**Final Safety Evaluation Report**  
 on the Construction Authorization  
 Request for the Mixed Oxide Fuel  
 Fabrication Facility at the Savannah  
 River Site, South Carolina

Docket No. 70-3098

U.S. Nuclear Regulatory Commission  
 Office of Nuclear Material Safety and Safeguards  
 Washington, DC 20555-0001

## **11.2 Aqueous Polishing Process and Chemistry**

**Figure 11.2-1 Acid Normality and Other Effects Upon Electrolytic Gas Generation**

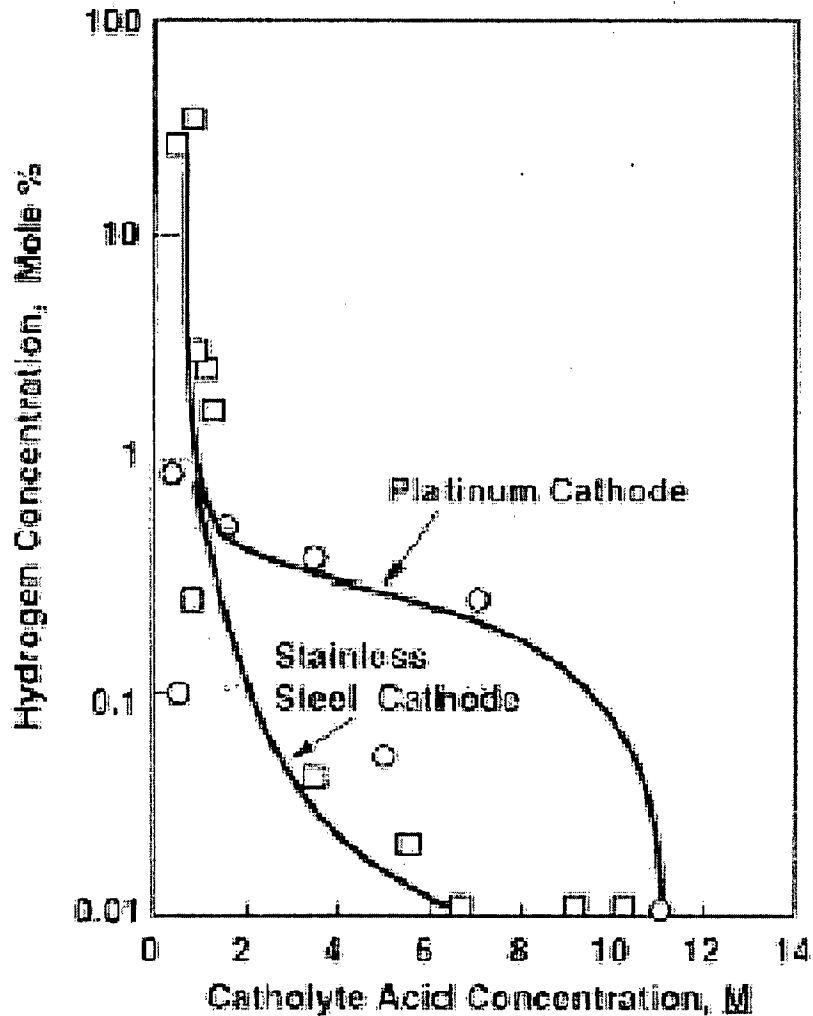
The applicant identified the silicon nitride barrier and elastomeric materials as PSSCs—these represent passive engineered controls. In addition, the electrolyzer is geometrically safe from a criticality perspective, seismically designed (as per Section 11.12.3.3 of the revised CAR, which addresses B2 elements for seismic structural integrity), and can withstand turbulent flow without inducing vibration.

The applicant also noted that the nitric acid provides a liquid heat sink for cooling during operations, and that protection features exist to limit operations. There will be a current leakage detection system and a trip circuit on the rectifier, which represent the active engineered controls. The current leakage detection system is designed as a permissive signal and will stop the startup process (i.e., not allow the power to be turned on during startup) or cease operations (i.e., turn the power off to the electrolyzer) if the leakage current setpoint of 10 mA is exceeded. The trip circuit of the rectifier is another protective feature during operations. The rectifier normally supplies the electrolyzer with 400 A at 30 V. The trip setpoint is 420 A, and the rectifier is physically incapable of providing more than 900 A. The current leakage detection system and the trip circuit are part of the PSCS, an existing PSSC for active engineered controls.
